Address:	Wolfson House 2-10 Stephenson Way NW1 2HE		1
Application Number(s):	2019/0162/HS2	Officer: Laura Hazelton	
Ward:	Regents Park		
Date Received:	11/01/2019		
Proposal: Submission under Schedule 17 of High Speed Rail (London - West Midlands) Act 2017 for plans and specifications for the erection of the replacement London Underground Traction Substation and Vent Shaft.			
Background Papers, Supporting Documents and Drawing Numbers:			
1EW02-CSJ-AR-DSP-SS06-137021, 1EW02-CSJ-AR-DEL-SS06-137221, 1EW02-CSJ-AR-DEL-SS06-137222, 1EW02-CSJ-AR-DEL-SS06-137223, 1EW02-CSJ-AR-DEL-SS06-137224, 1EW02-CSJ-AR-DEL-SS06-137232 Rev P02.1 and 1EW02-CSJ-AR-DEL-SS06-137233 Rev P02.1.			
RECOMMENDATION SUMMARY: Grant planning permission subject to conditions			
Applicant:	Agent:		
High Speed Two (HS2) Limited High Speed Two (HS2) Limited 1 Eversholt Street London NW1 2DN	Costain Skanska Joint Venture (CSJV) The Podium 1 Eversholt Street London NW1 2DN

OFFICERS' REPORT

EXECUTIVE SUMMARY

Figure 7: Existing (above) and Proposed (below) context surrounding the vent shaft and substation building, shown to the centre.

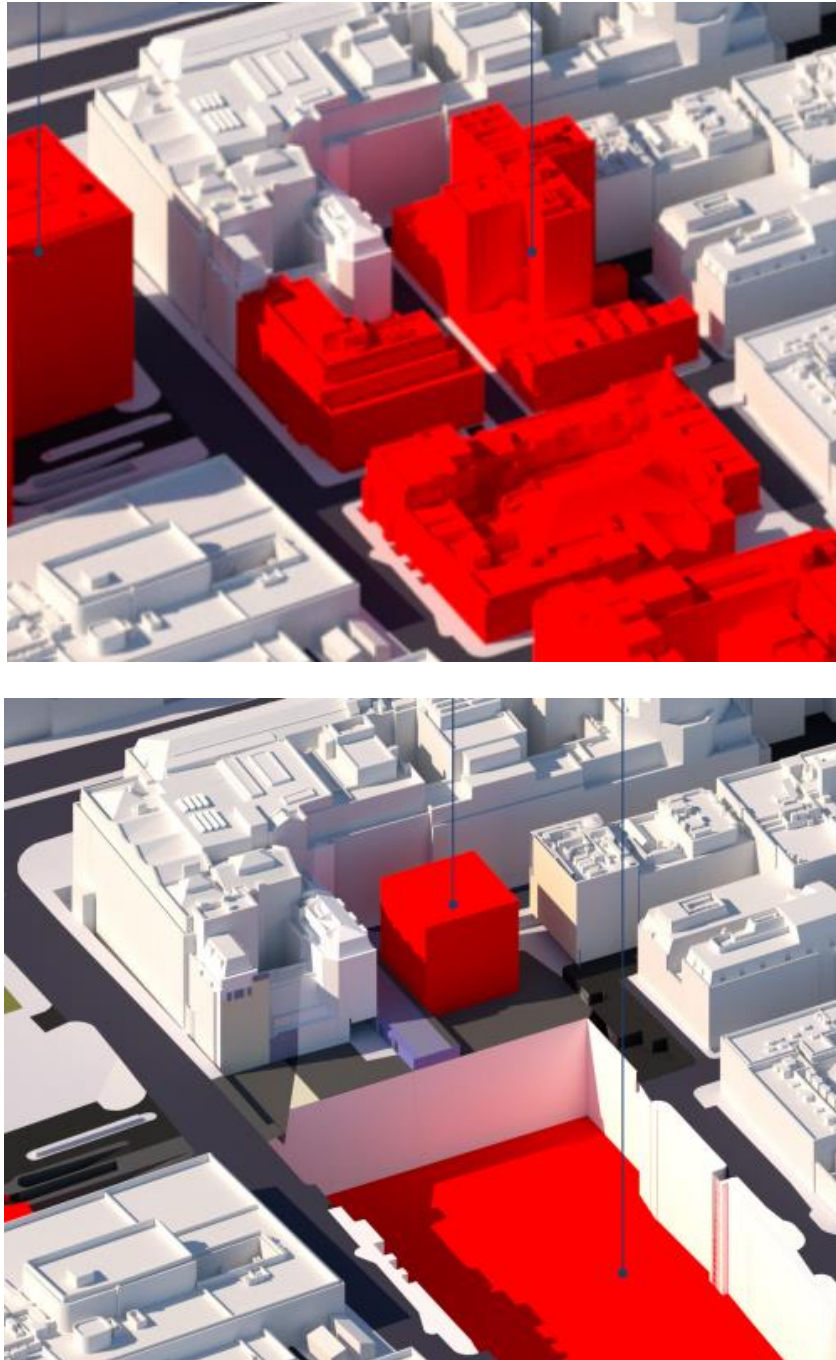
- 10.16 The Bloomsbury CAAC also suggested that the upper fifth of the building should be set back to reduce the impact on the setting of the rear elevation of 30 Euston Square. As discussed above, the proposed building is not considered to result in additional impact or harm to the setting of 30 Euston Square when compared to the existing situation, and as such, Officers have not

encouraged the applicant to explore setting back of the top storey of the proposed building. Furthermore, it is considered that doing so would weaken the architectural intent to create a standalone, sculptural, cuboid structure, and as such, would be unlikely to be considered appropriate for the current proposals.
